**STAFF REPORT**  
**COMMUNITY DEVELOPMENT DEPARTMENT**

HEARING DATE: 1/14/2025  
TO: Mayor & City Council  
FROM: Nick Napoli, Associate Planner  
208-884-5533  
SUBJECT: Gander Creek South No. 4  
FP-2024-0021  
LOCATION: Generally located south of W. McMillan Road on the south side of the Five Mile Creek, west of N. McDermott Road, I the NE ¼ of Section 31, T.4N., R.1W.

Final Plat consisting of 26 residential building lots and three (3) common lots on approximately 4.58 acres of land in the R-8 zoning district by Bailey Engineering.

B. Final Plat (dated: 08/30/24)

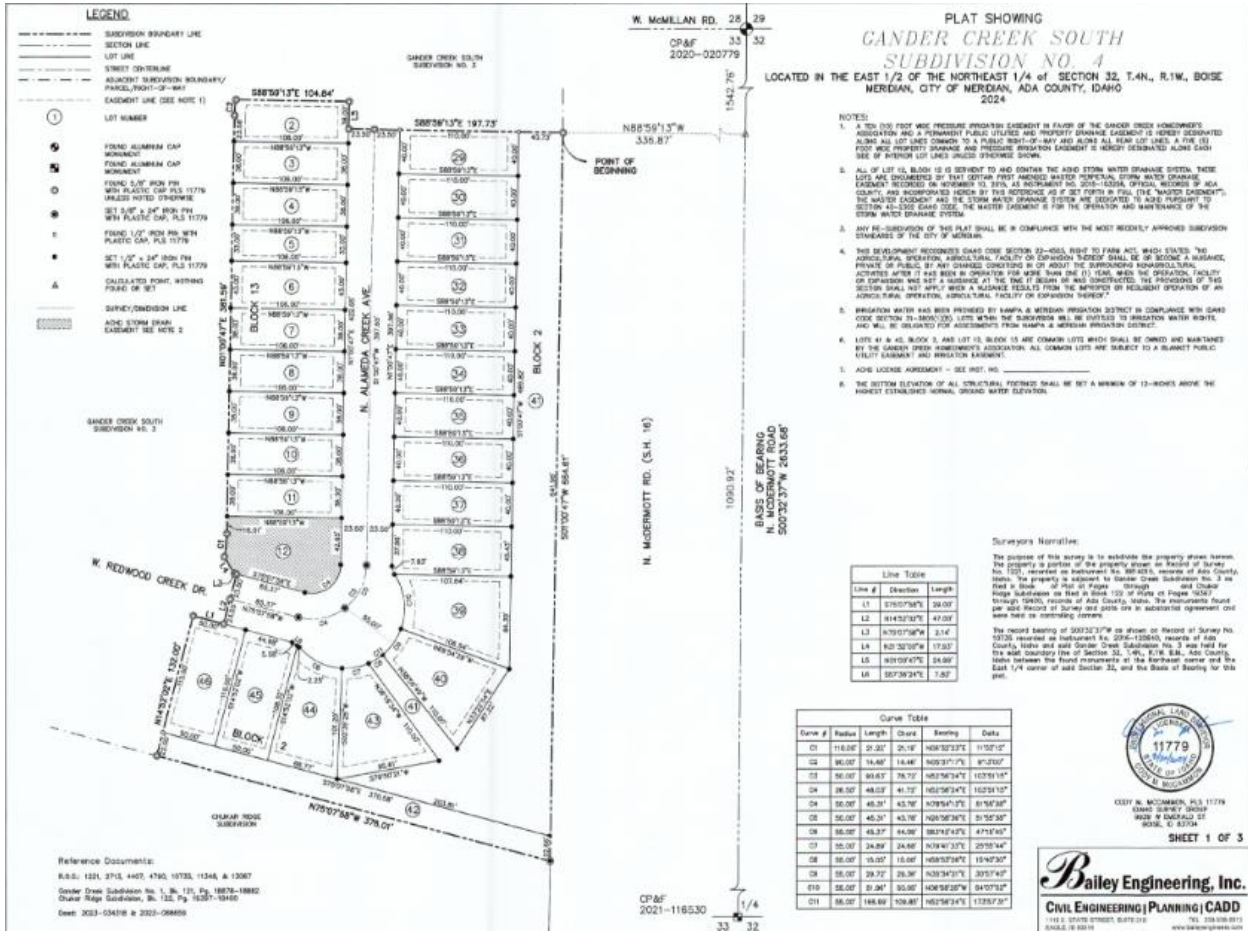
3. Prior to submittal for the City Engineer's signature, have the Certificate of Owners and the accompanying acknowledgement signed and notarized.
4. The final plat shown in Section V.B prepared by Bailey Engineering Inc., stamped on 08/20/2024 by Cody M. McCammon, shall be revised as follows:

- a. Note #7: Include the recorded instrument number for the ACHD license agreement.
  - b. W. Redwood Creek Drive shall have an arrow showing the location on the plat.

*An electronic copy of the revised plat shall be submitted prior to signature on the final plat by the City Engineer.*

C. Landscape Plan (dated: 7/12/2024)

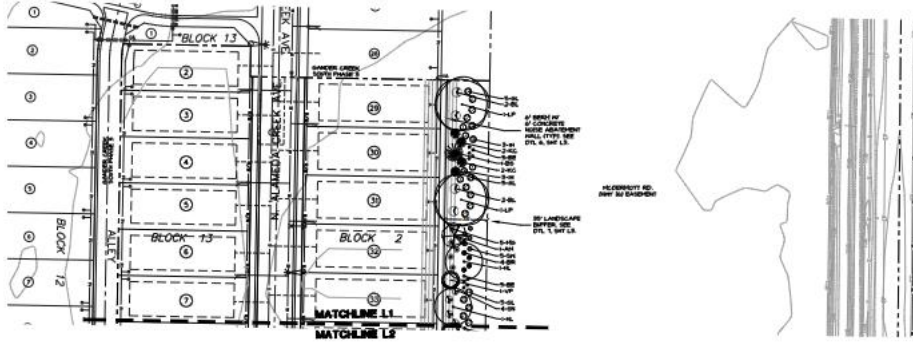
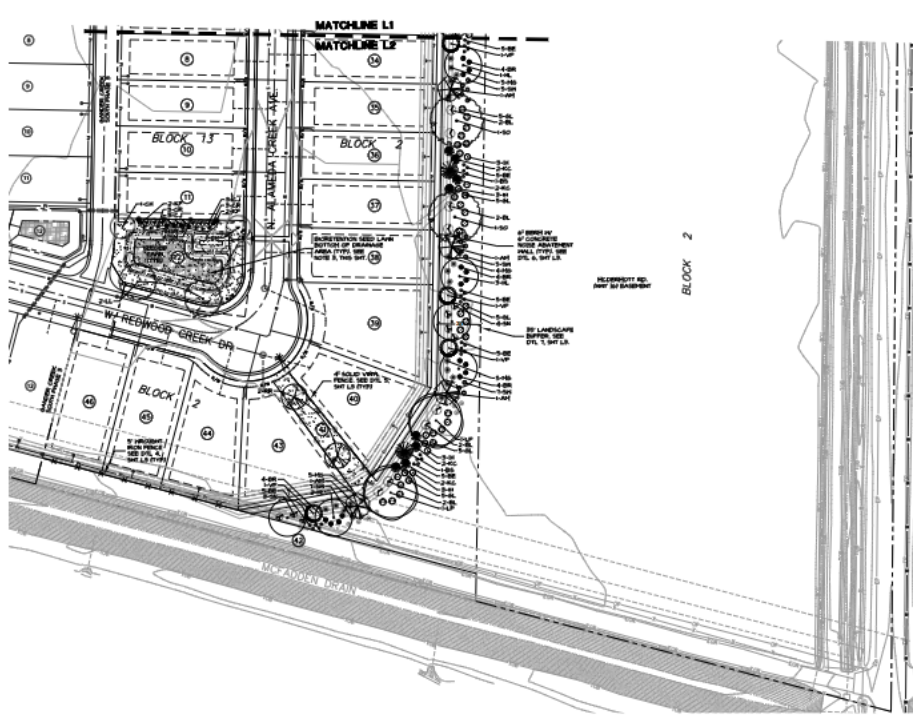
5. The landscape plan shown in Section V.C, dated 08/05/24, is approved as shown in Exhibit C.
  - a. A detail shall be included that depicts the centerline (or estimated centerline) of the future SH-16 in relation to the top of the berm/wall verifying it's a minimum of 12-feet higher than the elevation at the centerline of the state highway as required by UDC 11-3H-4D.2. The Director may approve alternative compliance as set forth in UDC 11-5B-5 where the Applicant has a substitute noise abatement proposal in accord with ITD standards and prepared by a qualified sound engineer as set forth in UDC 11-3H-4D.4.

- b. The 6-foot tall closed vision fence along the east boundary of the subdivision adjacent to N. McDermott Rd./future SH-16 shall be removed and either a use easement recorded across the back side of the berm along McDermott/SH-16 benefitting adjacent building lots with allowance for side yard fences to be constructed to the wall on top of the berm; or, an open vision, 4-foot tall closed vision, or 4-foot tall closed vision with 2 foot open vision fencing on top could be constructed for visibility of the common area between the fence and wall on top of the berm.
